DS-K1T342 Series MinMoe Release Notes
(2026-2-4)

| Device Model:

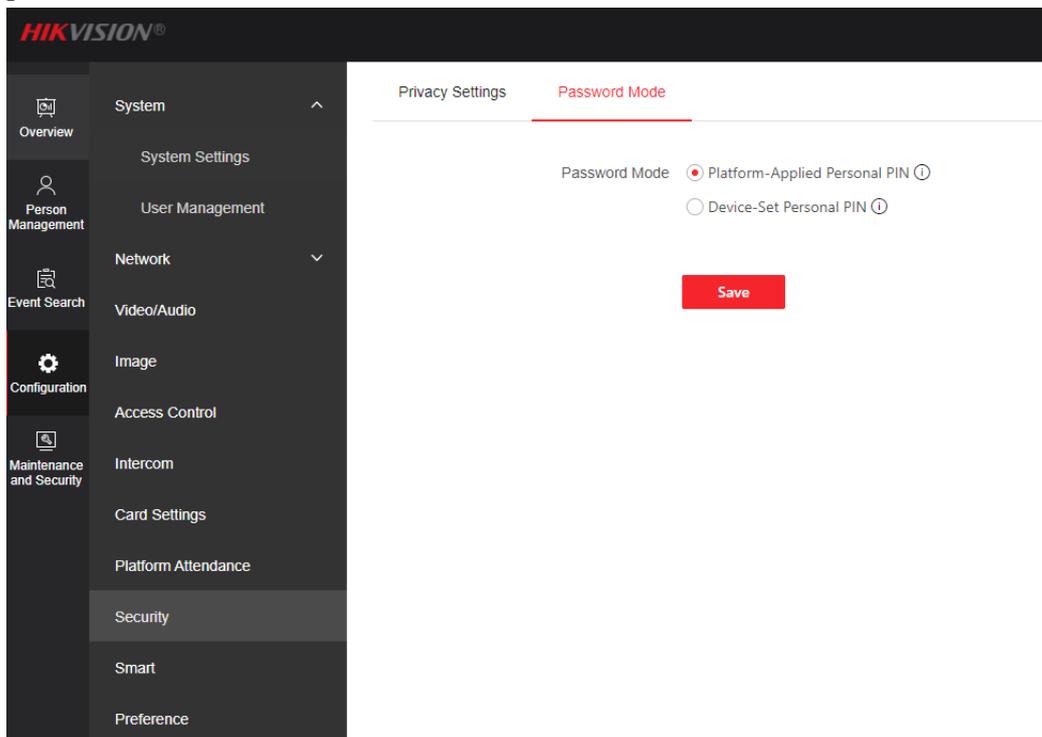
2. PIN Code supports switching between platform applied personal PIN mode and device set personal PIN mode

Open web client, go to Configuration-Security-Password mode to switch PIN Code mode. In platform applied mode, cannot edit PIN Code on web client, it needs to be set on platform. In device set mode, can edit PIN Code on web client or local UI and PIN code set by platform is invalid.

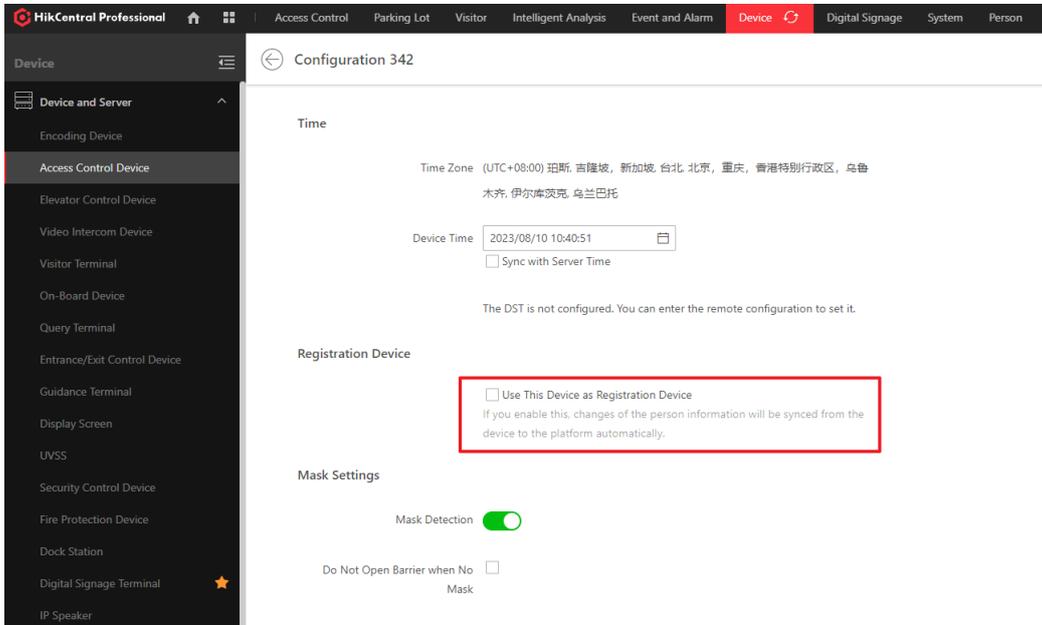
3. Support sync person information to platform automatically

Notice:
a. Platform requirement: HCP V2.4.1 or HCAC V2.1.1
b. Only ISAPI or ISUP protocol supported
c. Need to set up on platform first. If you enable this function , changes of the person information will be synced from the device to the platform automatically

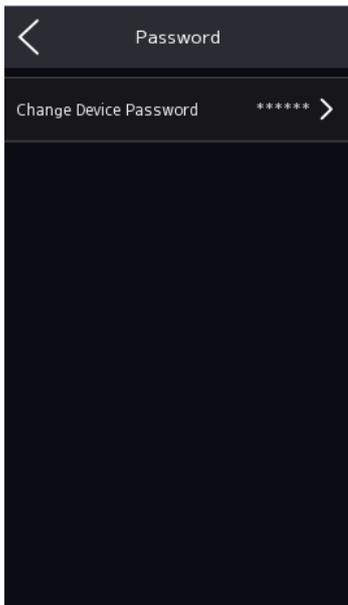
4. Supports modifying device password locally

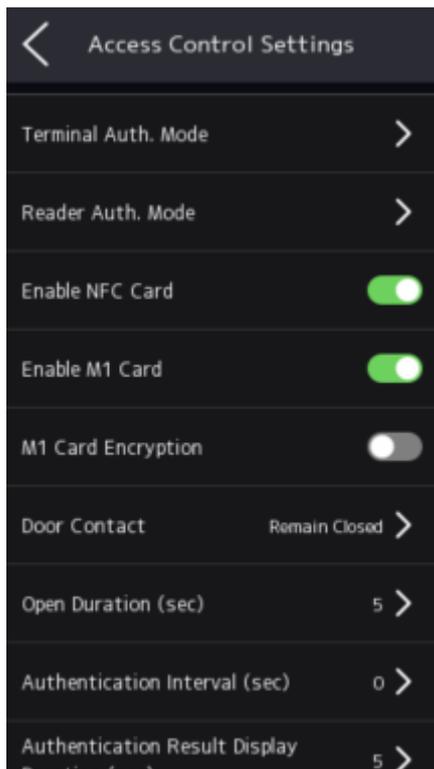
5. Supports enable M1 encryption locally

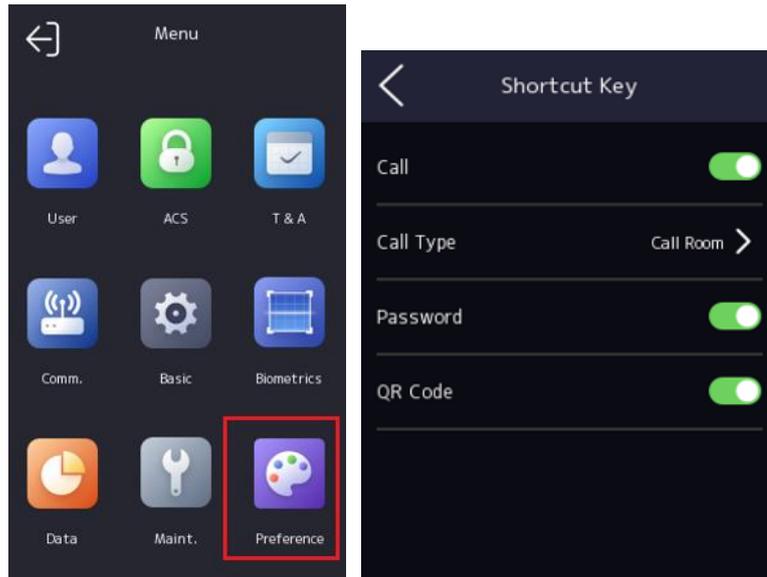
5. ISAPI protocol makes it easier for integration with third-party software;
6. Remote video intercom and unlock door from Hik-Connect App on your mobile/Pad
7. Support Hik-ProConnect platform to realize Cloud access control and time attendance management
8. Support ISUP 5.0 protocol to manage devices located in different locations;
9. When open device for the first time, wizard for activation and basic configuration. Including select language, application mode, select and configure network, Hik-Connect, privacy settings, add administrator face and card
10. Self-defined shortcut key (Call Room, Call Center, Call Specified Room, Call App and Password) on main interface;

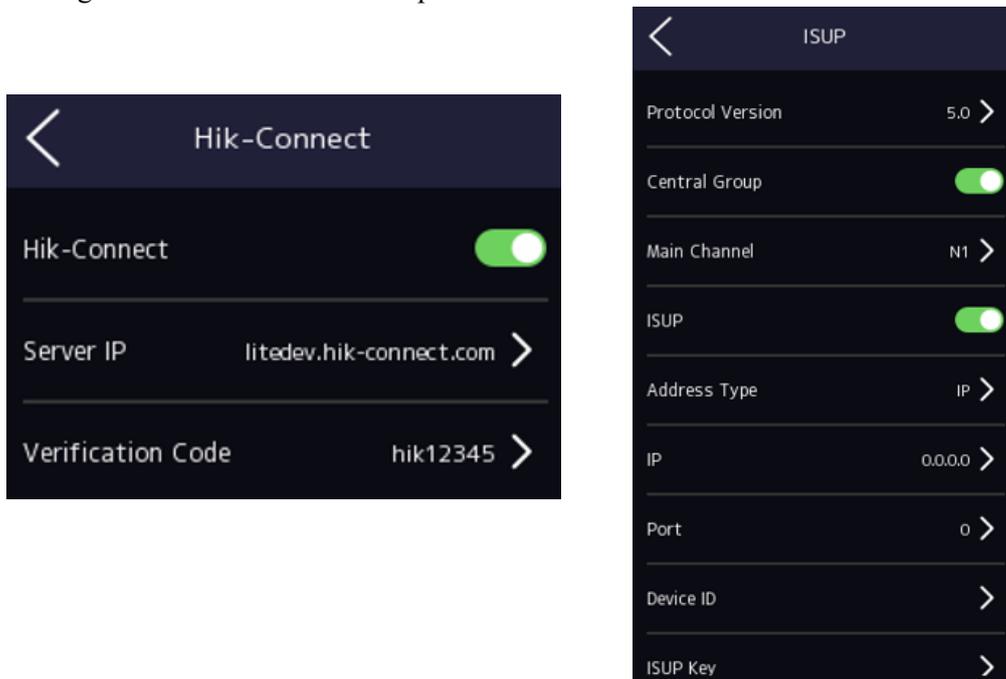
11. Configure ISUP and Hik-Connect parameter in device local menu

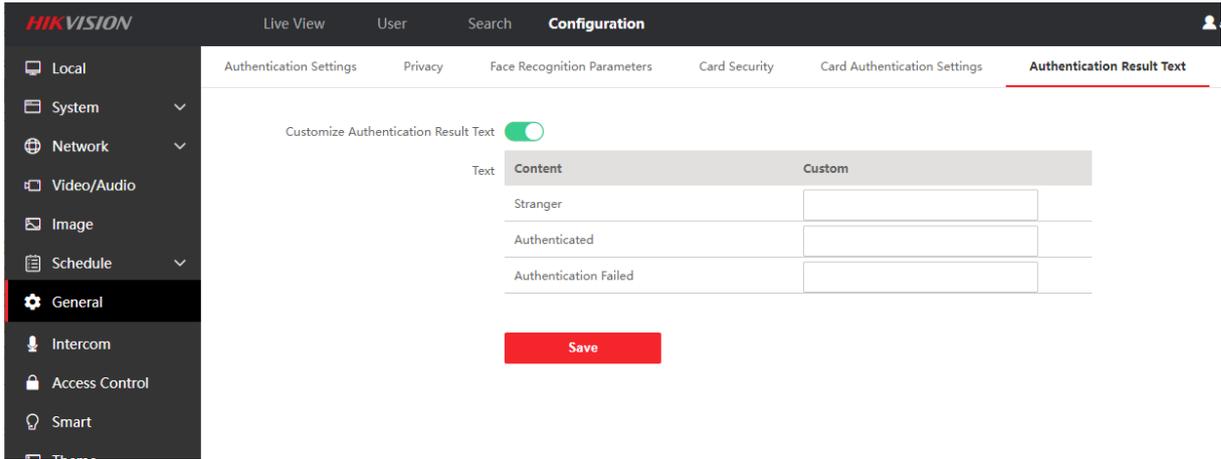
14. **The displayed authentication result text can be customized**, edited through the web, including the scope of the results of stranger, authentication success and authentication failure.

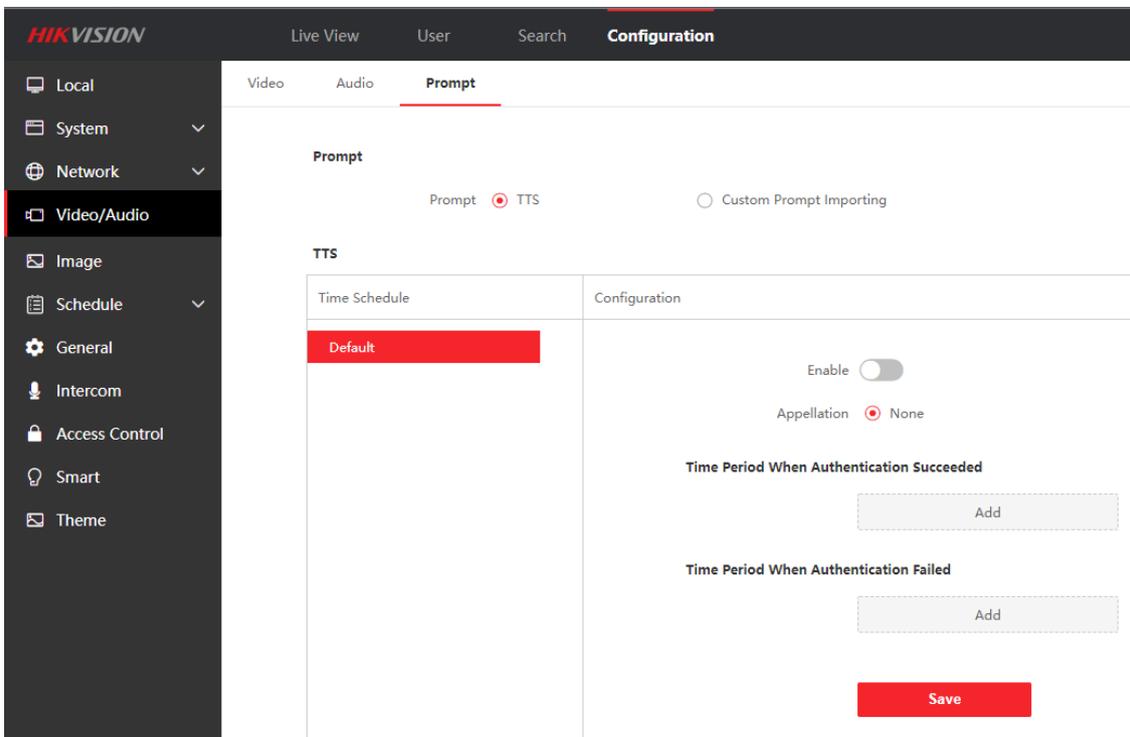
15. Self-defined voice prompt (TTS function, English only) and screen display info (user ID, name and face picture) for authentication;

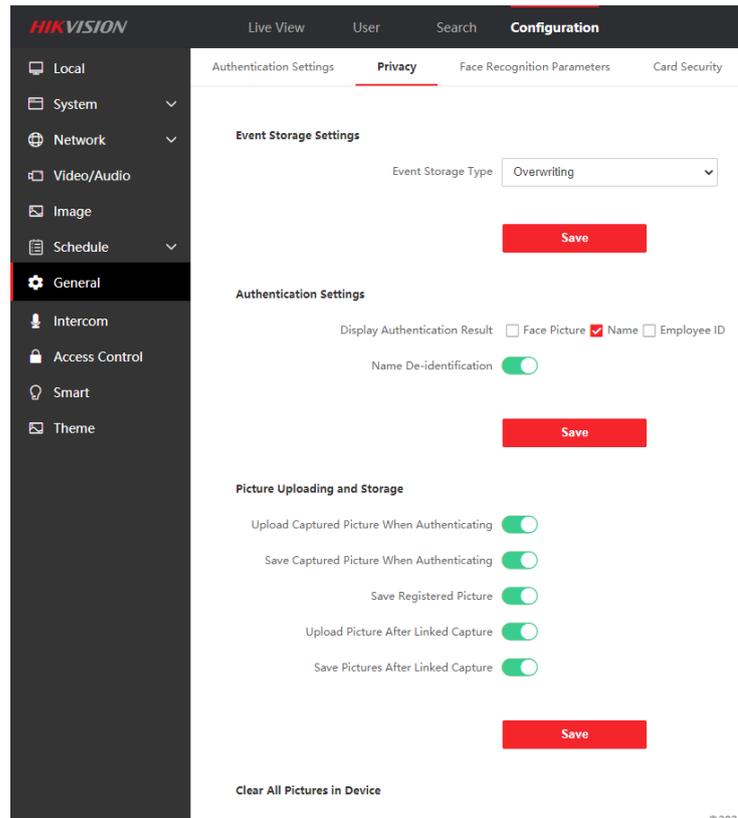
16. **Network**

Support TCP/IP and Wi-Fi (model with W only), adapt to LAN(network) or WAN(ISUP 5.0) network environment.

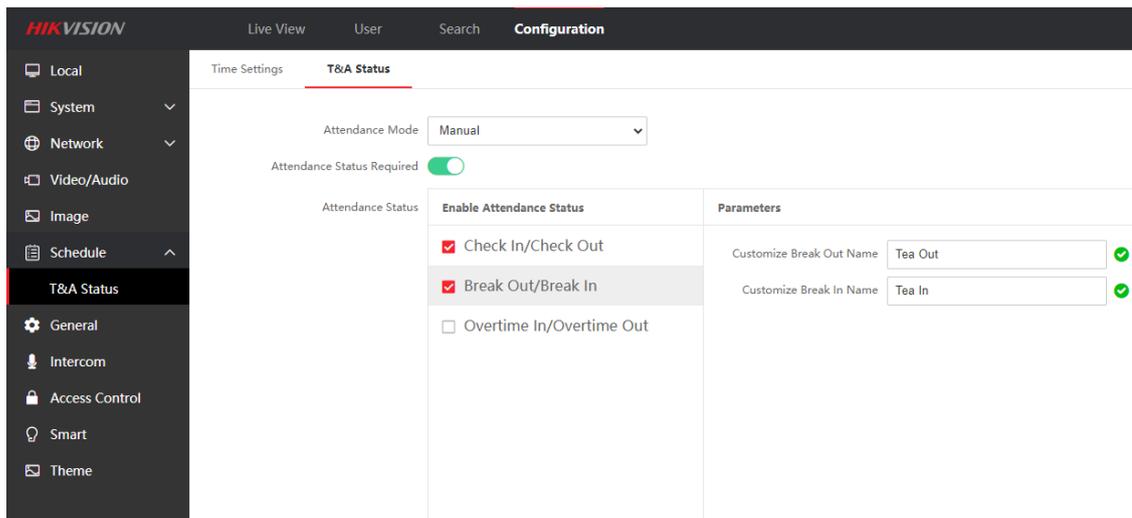
17. **Function**
    a. Support face mask recognition.
    b. Video intercom with indoor station, master station and platform;
    c. Multiple verification modes: Face, card, fingerprint(-F only), PIN code;
    d. Support check in/check out/break out/break in/overtime in/overtime out attendance status, and self-define status name;

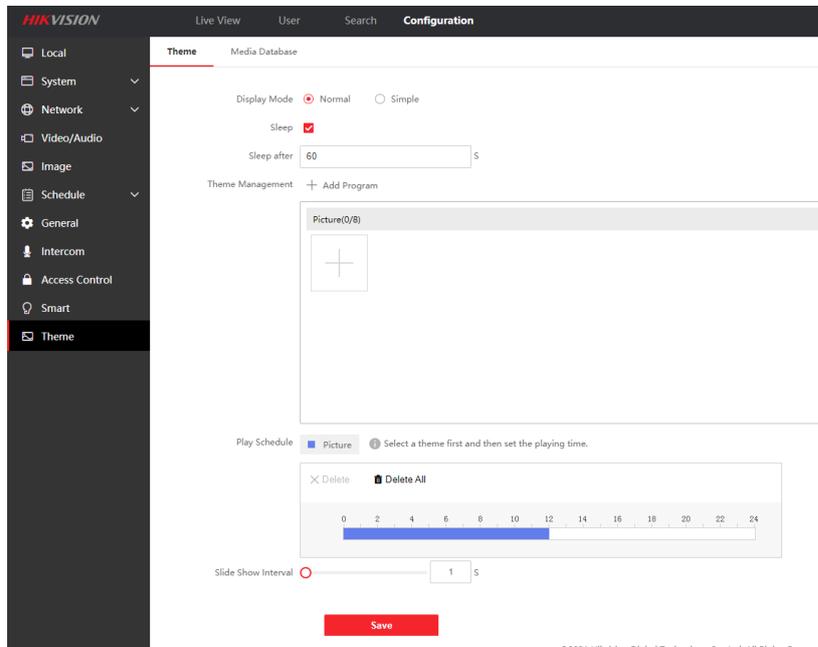
e. Support custom standby background image (max 8 pictures)
